Walsh Bay Arts Precinct

Modification Application
Mod 7

February 2022

Sydney Dance Company Louvres

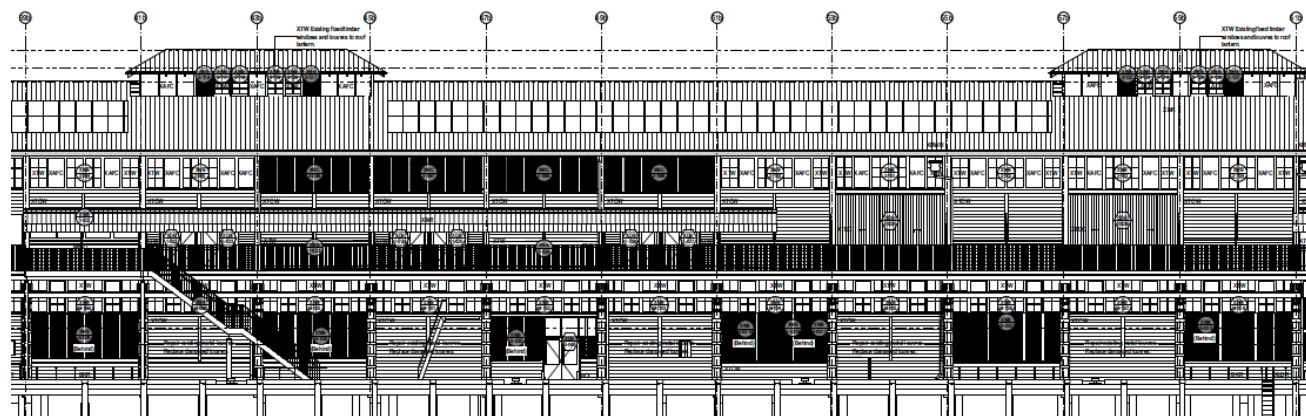
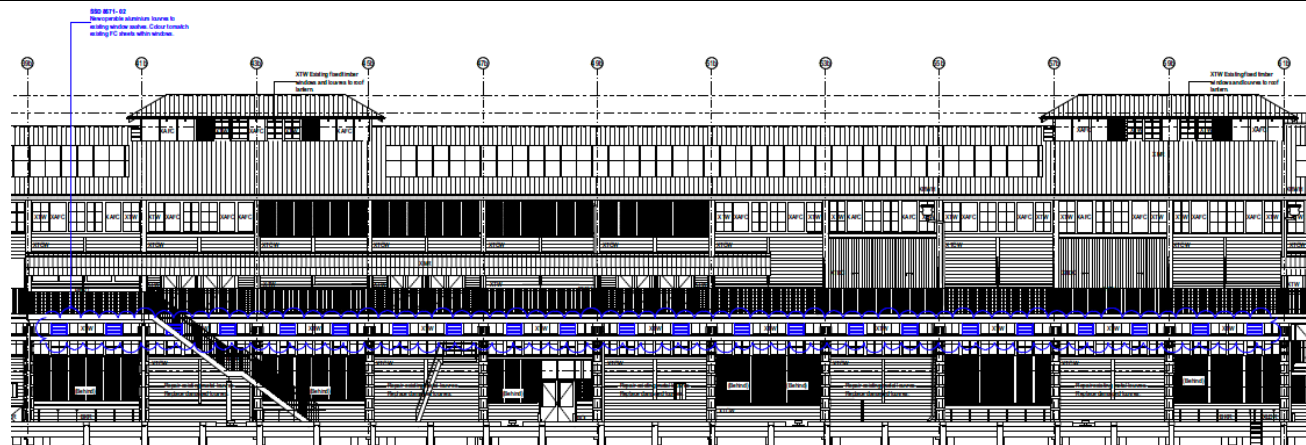
The proposed louvres will assist with natural ventilation of Studios 1-4 and in maintaining occupant comfort. The 22 louvres will replace existing fibre cement (non-heritage) sheeting that is located on the upper sash of every 2nd and 5th window along the façade. The louvres will be aluminium and be painted to match the colour of the existing fibre cement sheeting.

Sydney Theatre Company Louvres

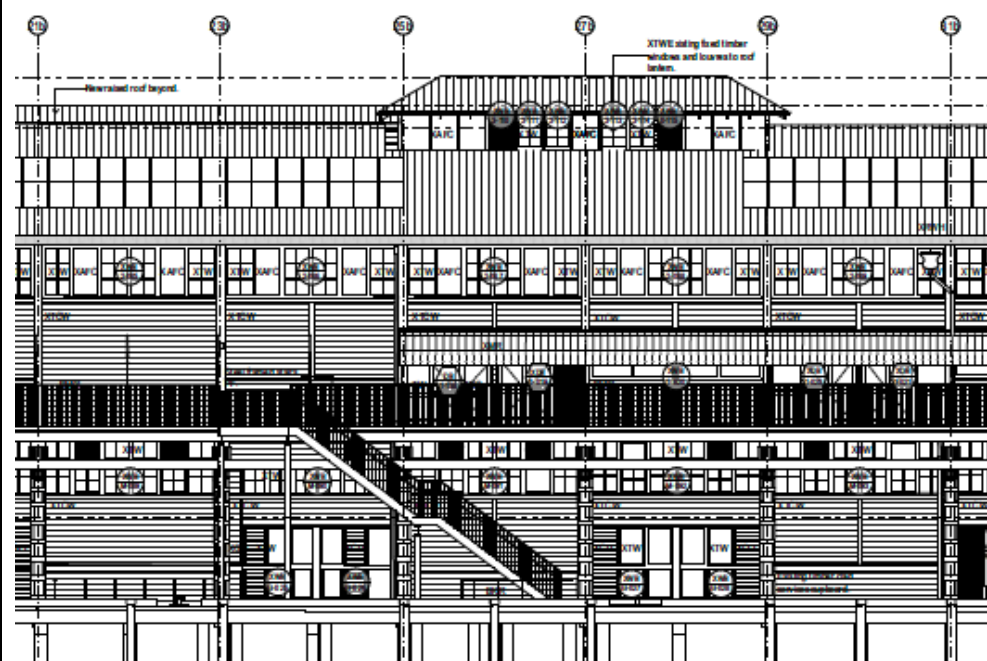
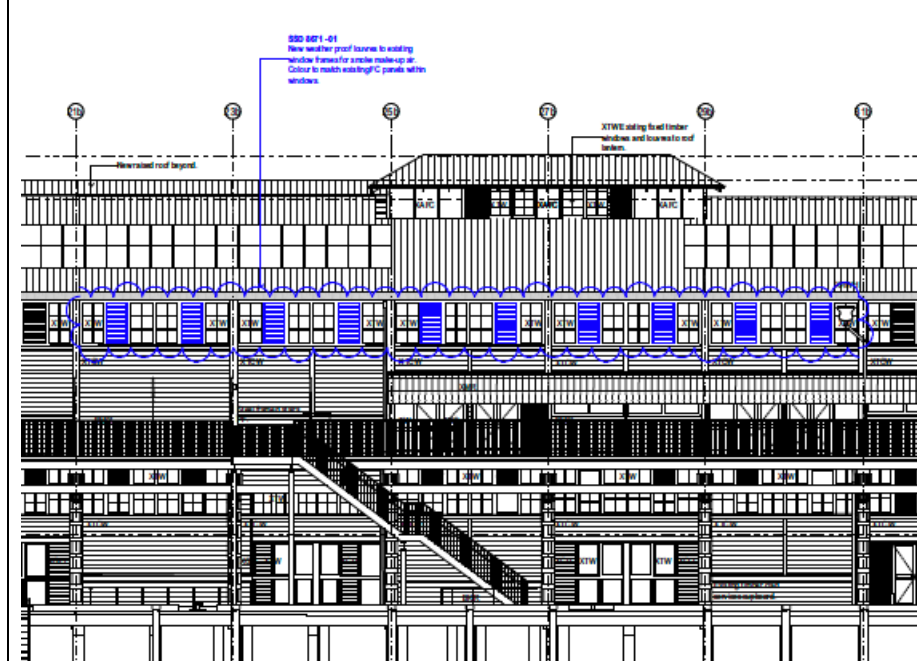
In order to ensure weather proofing of the Sydney Theatre Company tenancy, it is proposed to replace the louvres with new 'two-stage' louvres that will prevent the ingress of water. Due to the design of the two stage louvres, additional venting will be required which is proposed to be via the installation of an additional 10 louvres to replace existing fibre cement sheeting.

The proposed louvres will assist with weather protection of the space whilst maintaining requirements for smoke exhaust. The 10 louvres will replace existing fibre cement (non-heritage) sheeting currently fitted to window frames along the façade. The louvres will be aluminium and be painted to match the colour of the existing fibre cement sheeting.

Figure 3: West elevation of Wharf 4/5 – Replacement of existing FC panels with louvres to Level 1.

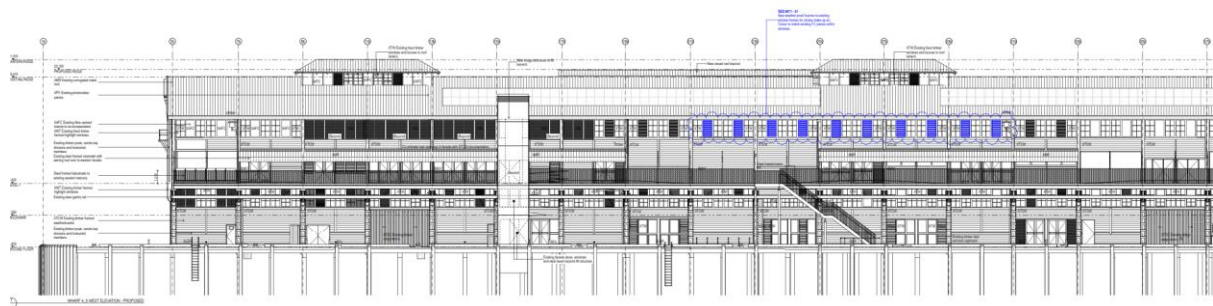
The projection of the wharf into the harbour has exposed the building to extreme weather, in particular rain and wind. Rainwater has been blown into the building through the existing glazed louvres along the western corridor on Level 1 (Figure 7). These existing glazed louvred openings (previously approved SSD8671) that facilitate smoke relief will be shut to prevent rainwater from entering the building.

Figure 4: West elevation of Wharf 4/5 – Replacement of existing FC panels with louvres to Ground Floor.

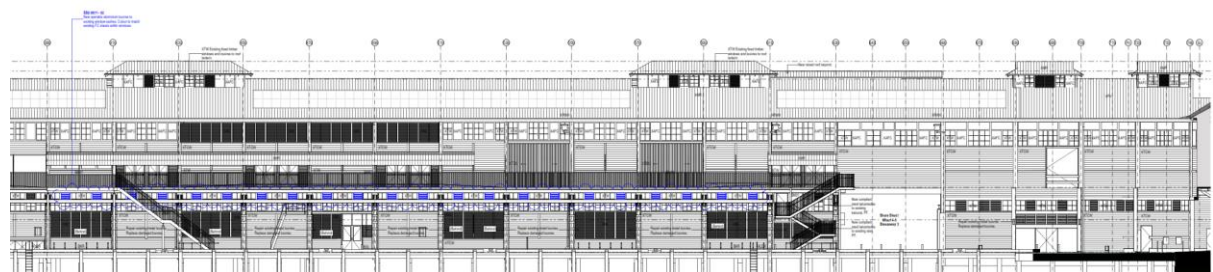
The proposed modification includes increasing the number of louvred openings to the façade to allow more hot air to be naturally vented out via increased fan speed and evaporative cooling.

The proposal involves replacing 22 existing FC (asbestos) panels with new operable aluminium powder coated louvres and frame.

Figure 5: Ground Floor plan of Shore Shed 4/5 (west) showing proposed upgrades to Commercial 2.

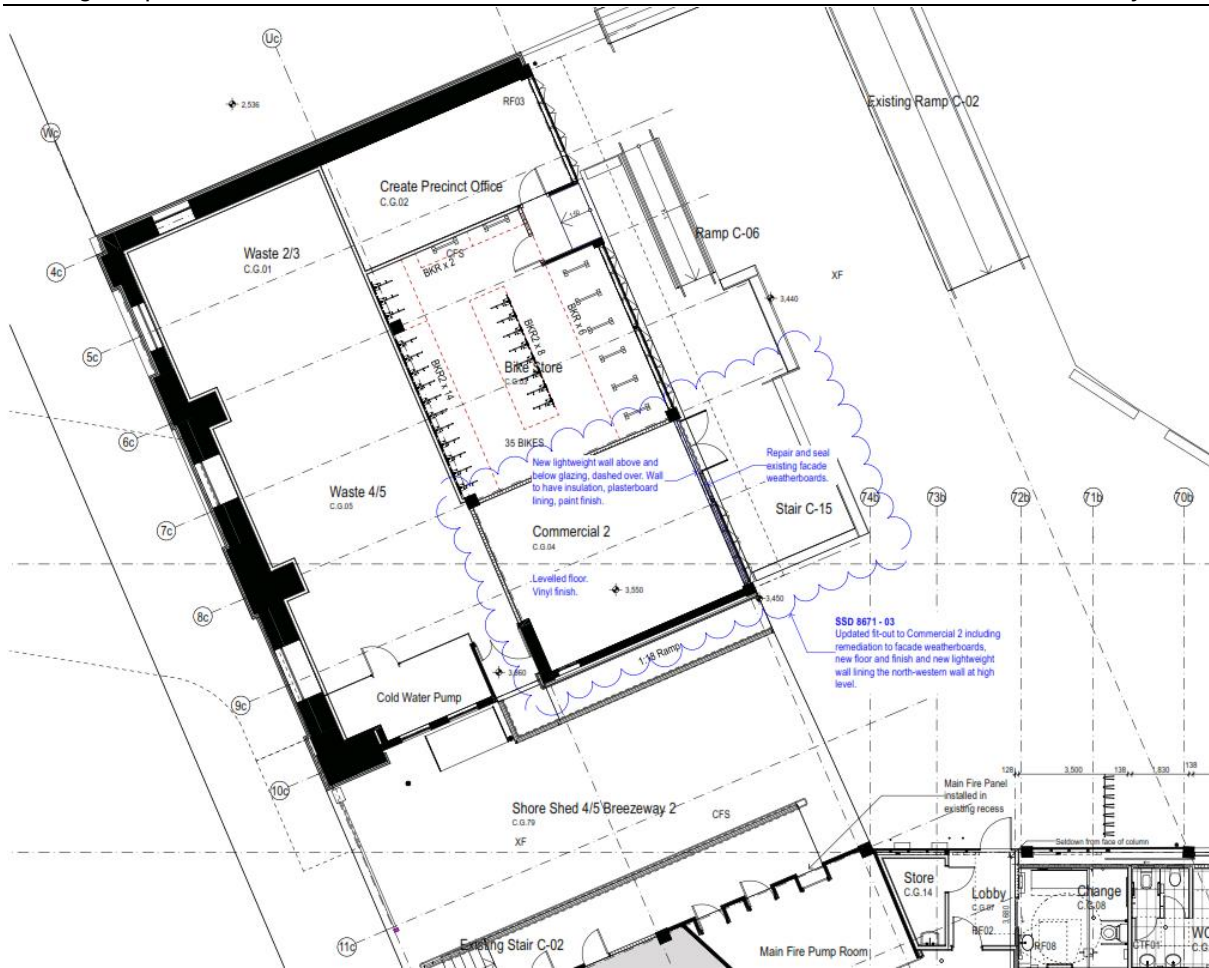
The majority of the repair work to Commercial 2 has been carried out under the original approved SSD. The current proposed upgrade works are minimal and will include repair and seal the external façade, level existing floor install new vinyl floor finish, and install of new thermal insulated lightweight plasterboard wall with paint finish to the northern wall.

Figure 6: Ground Floor Plan of Shore Shed 4/5 (east) showing proposed upgrades to Commercial 3 and 4.

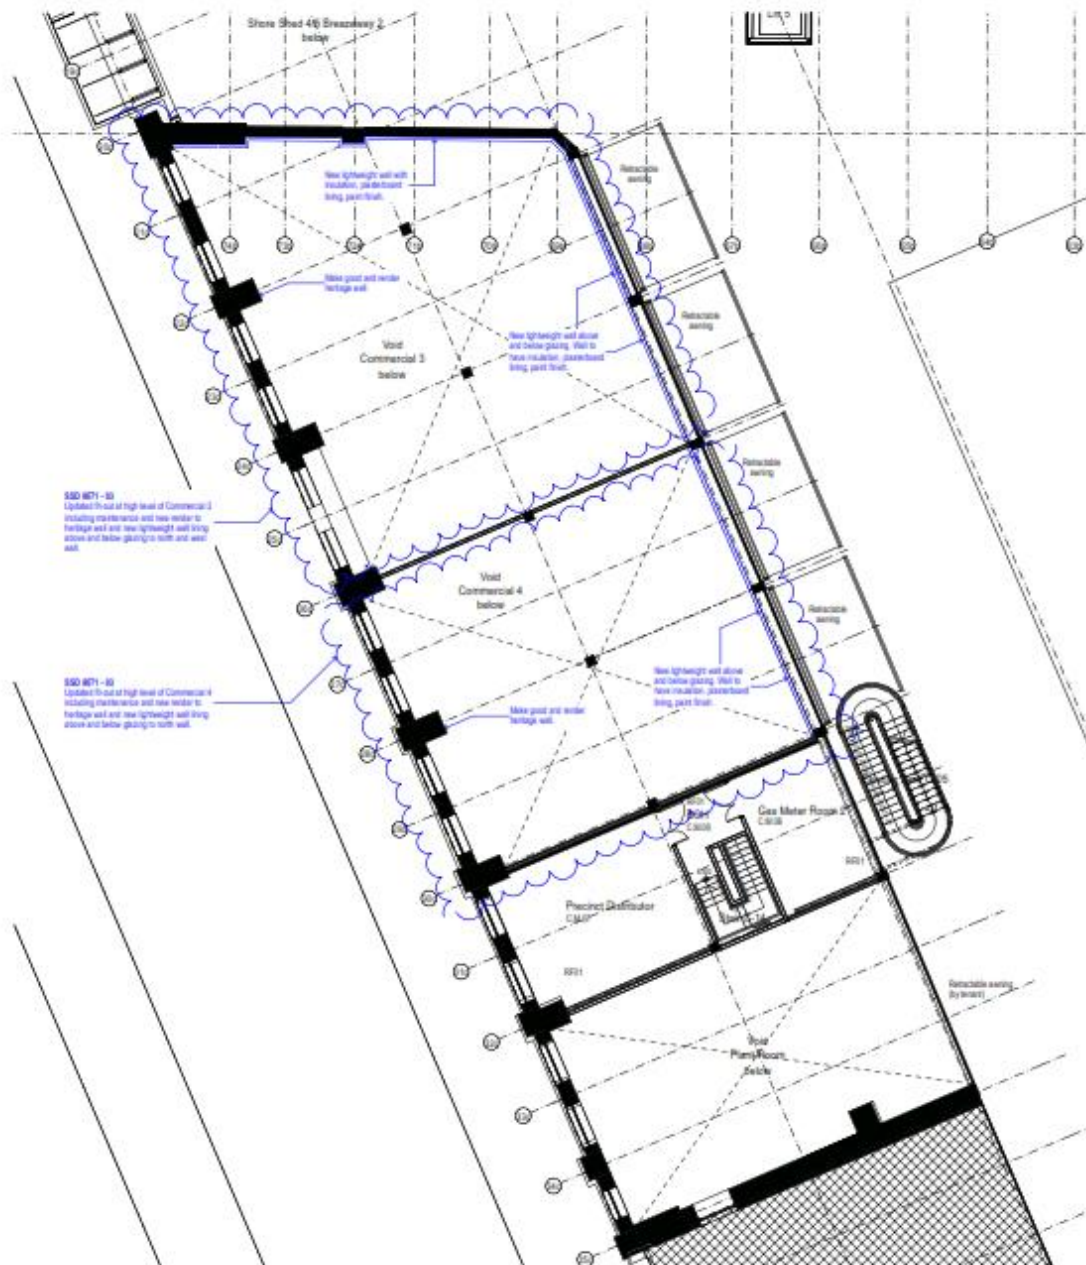
Note: The proposed plasterboard lining will be fixed to a new steel stud frame to the southern brick wall. This is where the previous toilet services were chased into the brick wall and wall tiles fixed to the brickwork. The new plasterboard wall is considered a less intrusive approach to cover previous unsightly damage where services and tiles have been removed and where poor cement mortar patchwork has been carried out (Figures 22 and 23). The plasterboard sheeting is necessary to create a safe wall surface and avoid further damage to the early significant brick wall.

Figure 10: Ground floor plan showing location of proposed high level louvres to western façade (Dance Studios).

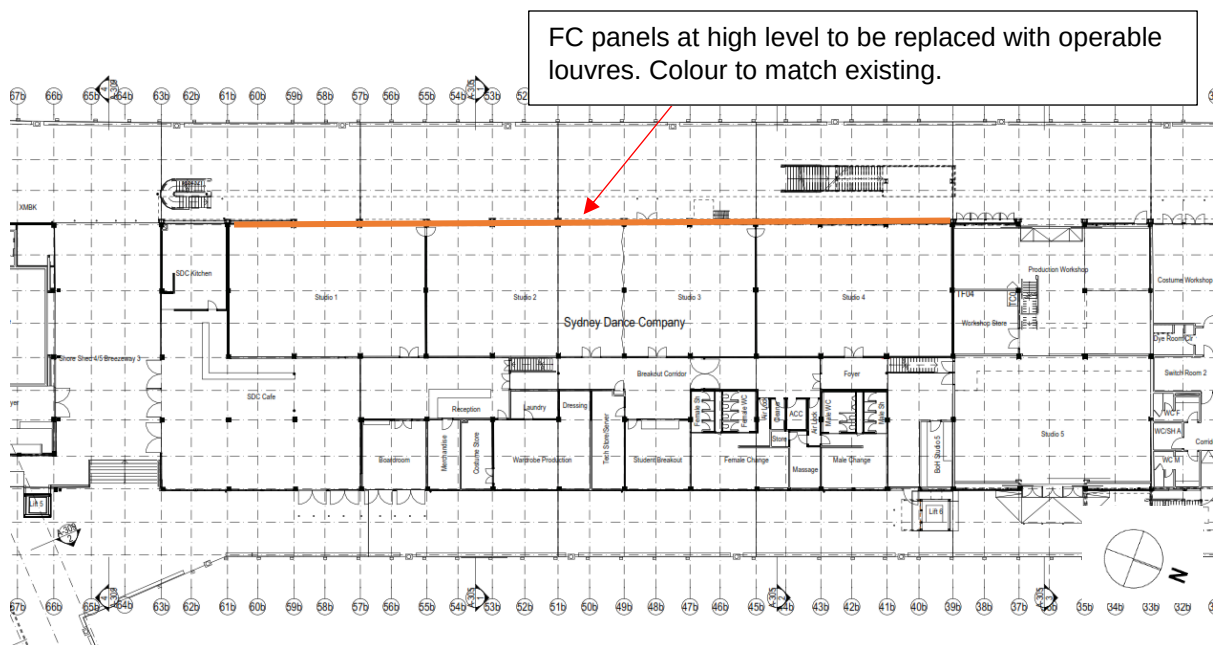
The proposal has been discussed with City of Sydney heritage specialist. Based on their advice, the proposed louvres must be painted to match the colour of the existing FC panels. This is to mitigate any visual impact and maintain the consistency of the overall appearance and regular façade pattern of the wharf.
